IN PLANNING PANELS VICTORIA**MELTON PLANNING SCHEME AMENDMENT C232MELT****TOOLERN DEVELOPMENT CONTRIBUTIONS PLAN REVIEW AND PRECINCT STRUCTURE PLAN REFRESH****PART A SUBMISSIONS ON BEHALF OF MELTON CITY COUNCIL****INTRODUCTION**

1. These Part A Submissions are made on behalf of Melton City Council (**Council**), the planning authority for Amendment C232melt (**Amendment**) to the Melton Planning Scheme (**Planning Scheme**). The Amendment seeks to implement Council's review of the Toolern Precinct Structure Plan¹ (**PSP**) and Toolern Development Contributions Plan² (**DCP**).

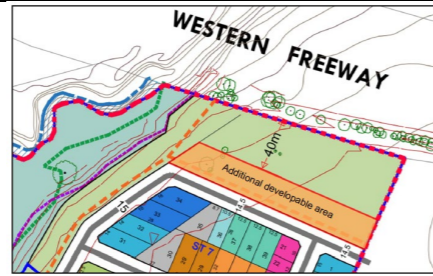
No.	Submission	Matters in Submission	Response to Submission
		<p>4. The FLP for BD19 in Appendix 1 in the Toolern DCP (page 81) identifies Property 126 as being outside of the Toolern DCP is incorrect.</p> <p>The plan should be corrected to state this is property 126 in the Toolern DCP.</p>	<p>Council has approved a subdivision outcome that differs from the FLP that has been prepared and is proposed to be incorporated into the Toolern DCP. This is to be expected as a FLP identifies land that is reasonably expected to deliver an optimal road design outcome and is used to determine land acquisition and construction costs to be incorporated into the DCP.</p> <p>It is recommended that the Functional Layout Plans and Property Specific Land Use Budgets remain unchanged.</p> <p>Discussions have been held with the Department of Transport and Planning (Transport) who have indicated that the land is needed for the freeway interchange. It is therefore recommended that a Public Acquisition Overlay should be applied to the land required for BD19 through a separate planning scheme amendment initiated by the Department of Transport and Planning.</p> <p><u>Clerical Errors</u></p> <p>4. Agreed. The FLP on page 81 for BD19 should amended to correctly identify property 126. The plan currently shows this property incorrectly as being located outside of the PSP.</p> <p>Amend Table 2 Property Specific Land Use Budget to match the FLP on Page 81. The land take for RD12 is identified as 1,277 sqm and the land take for BD19 is identified as 3,203 sqm which equates to 0.45 Ha (4,480 sqm).</p> <p>Recommend that Council present a panel version of the amendment to the planning panel hearing, including changes to:</p> <ul style="list-style-type: none"> • Correct the FLP for BD19 on Page 81 of the Toolern DCP. The FLP currently incorrectly identifies property 123 as being outside of the Toolern PSP area. • Amend Table 2 Property Specific Land Use Budget to include 0.45 Ha of land for 'arterial roads and bridges' for Property 126. <p>Submission not resolved. Refer the submission to the Planning Panel.</p>

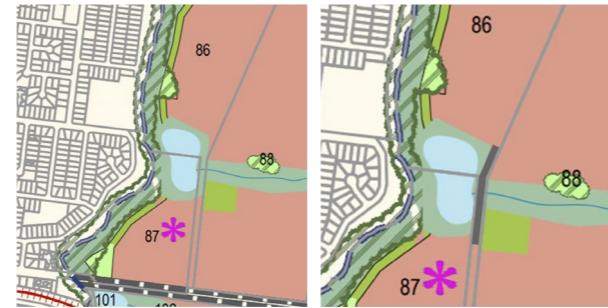
It is requested that the extent of passive open space on Property 87 be reduced in Table 2 of the Toolern DCP to eliminate the amount of passive open space now replaced with the drainage asset (see image below).

- Part of the increased drainage reserve is located on land that was shown as passive open space in the Future Urban Structure on property 86.

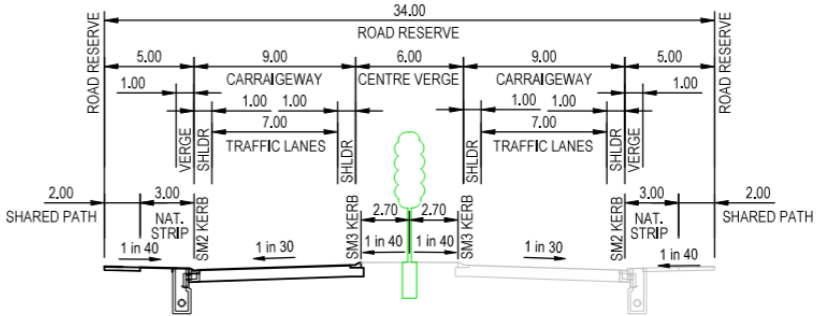
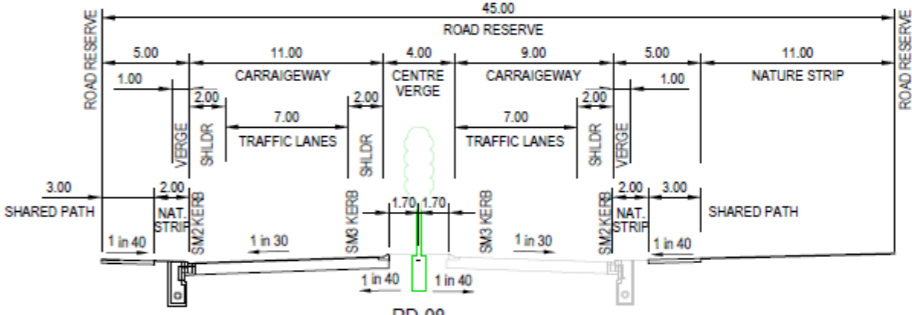
<p><i>Mount Cottrell Road</i></p> <ol style="list-style-type: none"> Inadequate land has been identified for the Mount Cottrell Road Freeway Interchange. Adequate land needs to be provided for the future intersections between Shogaki Drive and the Western Freeway. The reduction of RD12 from 45 metres to 41 metres is not supported. A minimum 45 metres is required to deliver the ultimate primary arterial corridor configuration. 	<p><i>Mount Cottrell Road</i></p> <ol style="list-style-type: none"> The land take for Bridge 19 (Mount Cottrell Road Freeway Interchange) was determined in the Paynes Road Precinct Structure Plan process and has not been reinterrogated through this Amendment. <p>DTP was given three opportunities to comment on the adequacy of the land take shown in Amendment C232melt (through the two rounds of FLPs and agency exhibition).</p> <p>Planning permit PA20/6946 has permitted a subdivision that has not reserved land for BD19 (Mount Cottrell Road / Western Freeway Interchange). This subdivision was referred to DTP</p>

No.	Submission	Matters in Submission	Response to Submission
			<p>(Transport for Victoria) and no request was made to reserve land for the interchange. As discussed in submission 18, it is recommended that DTP apply a Public Acquisition Overlay to the land required for the interchange.</p> <p>4. Intersections on Ferris Road between IT10 (Shogaki Drive) and BD19 (Freeway Interchange) are not Toolern DCP items. Any land for these intersections, which are left-in and left-out arrangements, are to be surrendered by the developer and are not subject to reimbursement from the DCP.</p> <p>5. Meetings were held with VicRoads, DTP and the VPA in 2015 and 2020 where it was agreed by all parties that Council would reduce the road cross-section for RD12 from 45 metres to 41 metres. DTP was given three opportunities to provide comments on the reduced land take shown in Amendment C232melt (two rounds of FLPs and agency exhibition). No concern was raised through these processes to reduce the road cross-section from 45 metres to 41 metres.</p> <p>The road width for RD12 is consistent with the approach taken by the VPA in contemporary PSPs where a primary arterial road is afforded a 41 metre road cross-section.</p>

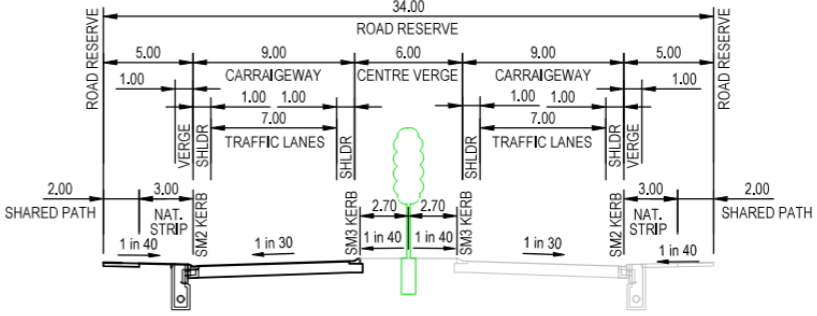
<p><i>Ferris Road</i></p> <p>9. Inadequate land has been reserved for the intersection of Ferris Road and Treeleaf Lane / Shakamaker Drive. The intersection does not adhere to current road design standards.</p> <p>10. DTP does not support the reduction of Ferris Road from 45 metres to 41.8 metres. A minimum 45 metres is required to deliver the ultimate primary arterial corridor configuration.</p>	<p><i>Ferris Road</i></p> <p>9. Multiple discussions were held with the VPA, DTP and VicRoads regarding the design of IT18 (Ferris Road and Treeleaf Lane / Shakamaker Drive) during the preparation of the FLPs.</p> <p>A staggered intersection is proposed which reflects the current location of the Treeleaf Lane which provides access to the Melton Recycle Facility and Shakamaker Drive which provides access to Tabcorp Park (see image below).</p>

No.	Submission	Matters in Submission	Response to Submission
			 <p>The presence of a deep quarry hole restricts the Treeleaf Lane leg moving to the north, and the land ownership restricts Shakamaker Drive moving to the south.</p> <p>Changes were made to the design of IT18 at the request of Council's engineers, DTP, VicRoads and the VPA during the two referral rounds for the FLP. In the end all parties agreed that the design adopted in Amendment C232melt best responded to the existing site constraints.</p> <p>10. Meetings were held with VicRoads, DTP and the VPA in 2015 and 2020 where it was agreed by all parties that Council would reduce the road cross-section for RD12 from 45 metres to 41 metres. DTP was given three opportunities to provide comments on the reduced land take shown in Amendment C232melt (two rounds of FLPs and agency exhibition). No concern was raised through these processes to reduce the road cross-section from 45 metres to 41 metres.</p> <p>The road width for RD12 is generally consistent with the approach taken by the VPA in contemporary PSPs where a primary arterial road is afforded a 41 metre road cross-section. RD15 (Ferris Road) has a modified cross-section of 41.8 metres.</p>

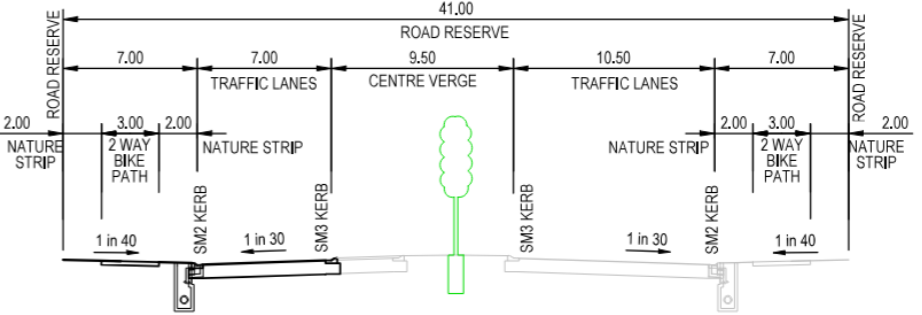
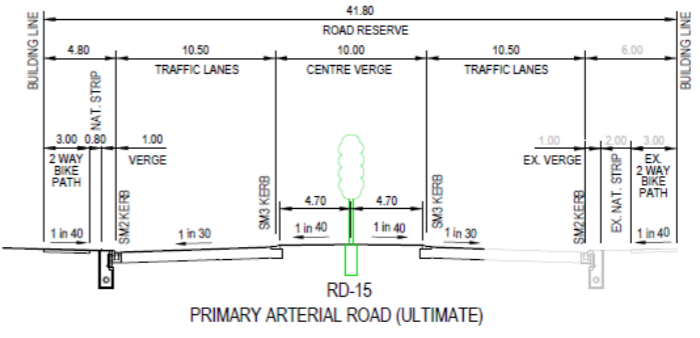
<p><i>Rail Corridor Interface</i></p> <p>11. DTP seeks clarification on how land requirements for the Paynes Road and Ferris Road road-over-rail grade separations will be delivered.</p> <p>It is noted that these grade separations have not been included in the PSP or DCP.</p> <p>12. Bridge 11 (BD11) has been removed under the assumption that a connection will be provided with the construction of the Thornhill Park Railway Station.</p> <p>There is no commitment from DTP to build this as part of any station upgrade. This crossing should be reinstated.</p>	<p><i>Rail Corridor Interface</i></p> <p>11. <u>Ferris Road Rail Overpass</u></p> <p>The land for the Ferris Road road-over-rail bridge will be acquired by the Victorian government through the Ferris Road level crossing removal project. The land is shown in the Toolern PSP and DCP documents as being required for the bridge. No money being collected through the DCP for the land acquisition as this is being acquired by the Victorian government.</p> <p><u>Paynes Road Rail Overpass</u></p> <p>The land required for the Paynes Road road-over-rail bridge is identified in bridge design (BD17) in the Toolern DCP. This design was prepared for the Rockbank PSP and DCP.</p> <p>Planning Permit PA18/6025 has been granted permitting the subdivision of the Thornhill Gardens estate. The subdivision has created a road reserve for the BD17 (see subdivision below).</p>

No.	Submission	Matters in Submission	Response to Submission
			 <p data-bbox="2249 583 2656 613">Land for the future Paynes Road Bridge</p> <p data-bbox="1724 632 2763 968"> 12. The Toolern PSP and DCP documents were amended to include the Thornhill Park Railway Station by Amendment C172 in February 2019. Bridge 11 (BD11) is located at the site of the future Thornhill Park Station. Railway Stations on the Melton railway line all include an underpass or overpass arrangement that provides access to platforms located on both sides of the rail line and provide access for commuters to platforms from both sides of the lane. BD11 would duplicate access that would normally be provided at the station and would add an additional cost for developers in the Toolern DCP. It is recommended that BD11 continue to not be included in the Toolern PSP or DCP documents. </p>
		<p data-bbox="691 989 1205 1018"><i>Melton Line Upgrade and Level Crossing Removals</i></p> <p data-bbox="649 1035 1605 1064">13. The Ferris Road Level Crossing removal is being constructed by the Victorian government.</p> <p data-bbox="649 1073 1679 1131">14. The Melton Line will be upgraded to introduce 9-car VLocity trains. A new train stabling facility is being investigated in Cobblebank.</p>	<p data-bbox="1765 989 2279 1018"><i>Melton Line Upgrade and Level Crossing Removals</i></p> <p data-bbox="1724 1035 1843 1064">13. Noted.</p> <p data-bbox="1724 1073 1843 1102">14. Noted.</p>

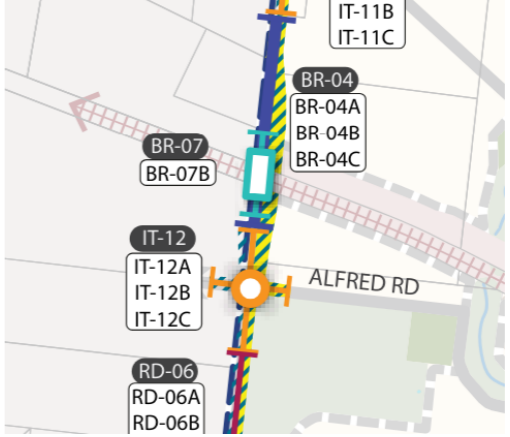
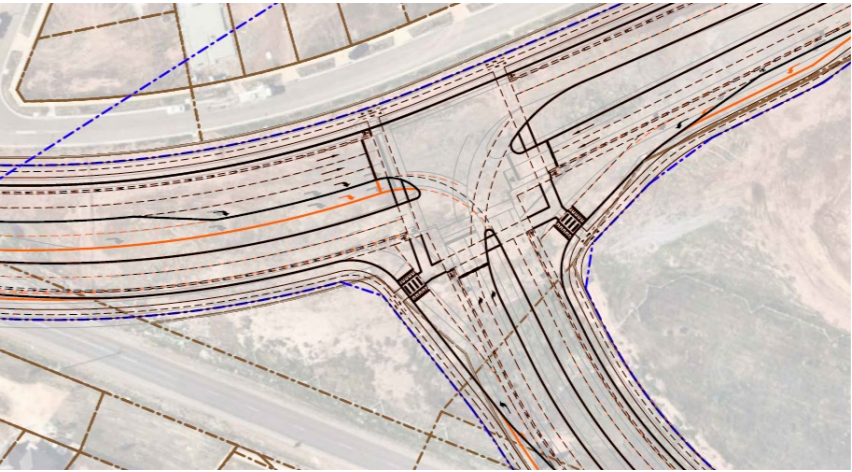
<p>8. Why has Paynes Road rail overpass been identified as a construction project only?</p> <p>Why is Mount Cottrell Road rail overpass a land project only?</p> <p>Why is Ferris Road rail overpass included with no funding?</p> <p>This appears to be an inconsistent approach by Council.</p>	<p>Council acknowledges that the Toolern PSP and DCP documents have taken different approaches to BD15 (Ferris Road Rail Overpass), BD17 (Paynes Road Rail Overpass) and BD20 (Mount Cottrell Road Rail Overpass).</p> <p><u>Ferris Road Overpass (BD15)</u></p> <p>BD15 (Ferris Road Rail Overpass) is currently being funded through the level crossing program.</p> <p>As the land acquisition and construction of this project is being funded by the Victorian government, neither the land acquisition nor construction costs are proposed to be included in the Toolern DCP.</p> <p><u>Paynes Road Overpass (BD18)</u></p> <p>BD18 (Paynes Road Rail Overpass) is a project that is identified as a construction project in the Rockbank PSP and 25% of the construction costs of this bridge is attributed to the Toolern DCP in the Rockbank DCP.</p> <p>This is identified as a future Council (secondary arterial) road. Council is proposing to amend the Toolern DCP to collect money for the construction of this bridge. The land has been excluded as the land has been reserved under planning permit application PA18/6025.</p> <p><u>Mount Cottrell Road Overpass (BD20)</u></p> <p>BD20 (Mount Cottrell Road Rail Overpass) is a future DTP (primary arterial) road.</p>

No.	Submission	Matters in Submission	Response to Submission
			<p>Discussions with DTP, VicRoads and the VPA in 2015 and 2020 identified that the construction of this overpass should be excluded from the DCP, however land acquisition should be included in the Toolern DCP.</p>
		<p>9. Why are bridges 9, 11, 12 and 13 being removed? It is not clear from the old or updated documents where bridges 12 and 13 were meant to be located.</p>	<p>Bridge 9 (BD09) is identified in the current Toolern PSP as a pedestrian rail underpass. BD09 is being removed as it is located next to a new vehicle bridge (BD16 – East Road). Only one pedestrian crossing is required in this location, and therefore it was recommended that BD09 be deleted from the DCP.</p> <p>Bridge 11 (BD11) is identified in the current Toolern PSP as a pedestrian rail underpass. BD11 is located next to the future Thornhill Park Railway Station. As Railway Stations typically provide an underpass or an overpass to link the platforms on both sides of the track it was determined that BD11 is no longer required.</p> <p>Pedestrian bridges 12 and 13 (BD12 and BD13) were not shown in the Toolern PSP and DCP documents when it was prepared. Meetings were held with Victorian government departments and agencies in 2015 and 2020, where it was agreed that the Toolern PSP provided sufficient pedestrian and vehicular bridges over the Toolern Creek and that BD12 and BD13 could be removed from the amended Toolern DCP.</p>

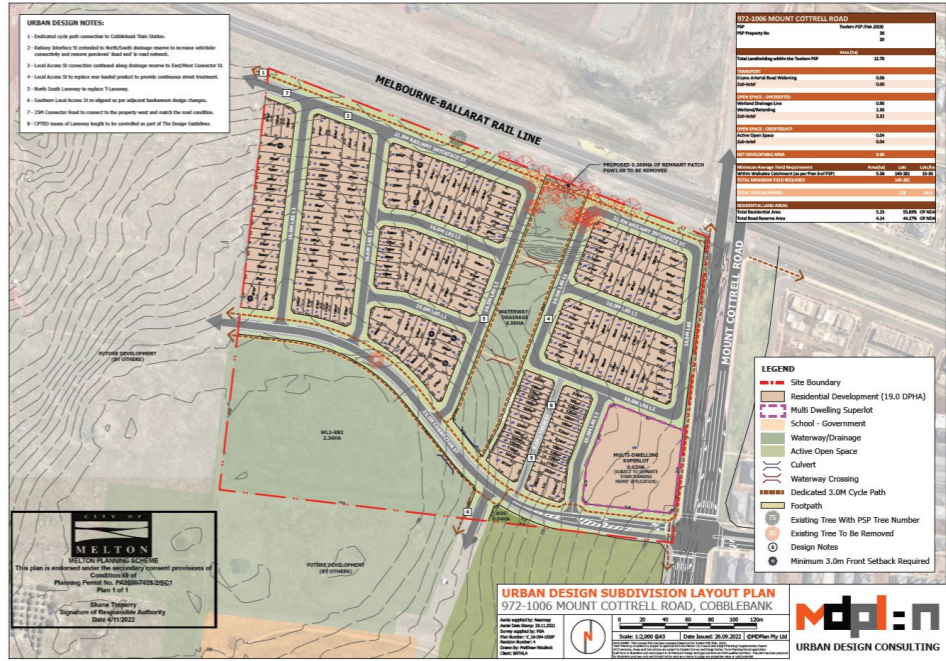
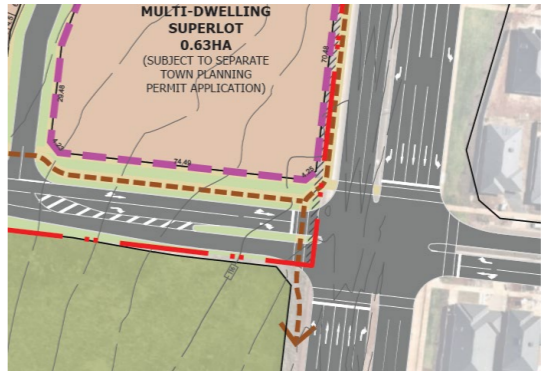
<p>10. RD08 cross-section is not consistent for both carriageways. Why is there a six-metre shoulder included in the cross-section, when the original sections had no shoulders. Recommend reducing the shoulder width and providing additional width on the shared user path (or dedicated cycling path).</p>	<p>This section of the east-west arterial road is known as RD08 in the Toolern PSP and DCP documents.</p> <p>At the advice of the Victorian government, a decision was made at the start of the review to use the VPA's <i>Benchmark Infrastructure Costings</i> report and methodology for the design of bridges, road cross-sections, road FLPs and intersection FLPs.</p> <p>The VPA <i>Benchmark Infrastructure Costings</i> report identified secondary arterial roads should be provided with shared paths on both sides of the road within the 34-metre road cross-section (see image below).</p>  <p>The VPA cross-section does not include on-road bicycle lanes or dedicated off-road bicycle paths on secondary arterial roads.</p> <p>The cross-section used in Amendment C232melt has modified the VPA's secondary arterial road cross-section to widen the two two-metre shared use paths to three-metre paths and has reduced the centre verge from six metres to four metres (see image below).</p>

No.	Submission	Matters in Submission	Response to Submission
			<p>Cardno have redistributed the four one-metre wide shoulders into three two-metre wide shoulders.</p> <p>Given the cross-section is based on the VPA <i>Benchmark Infrastructure Costings</i> report, no change is recommended to the cross-section or the FLPs.</p>
		<p>11. Why has RD08 reduced the number of lanes but retained the same cross-section width. What is the purpose of the 11 metre nature strip?</p>	<p>This section of the east-west arterial road is known as RD08 in the Toolern PSP and DCP documents.</p> <p>RD08 was originally identified as a primary arterial road in the Toolern PSP and DCP documents with a 45 metre cross-section.</p> <p>When the FLPs were being prepared Council had received planning permit applications for some of the properties containing RD08 which had based their subdivisions on a 45-metre road cross-section.</p> <p>The FLP has preserved the 45-metre road reservation to ensure that the planning permit applications lodged with Council were not prejudiced.</p>
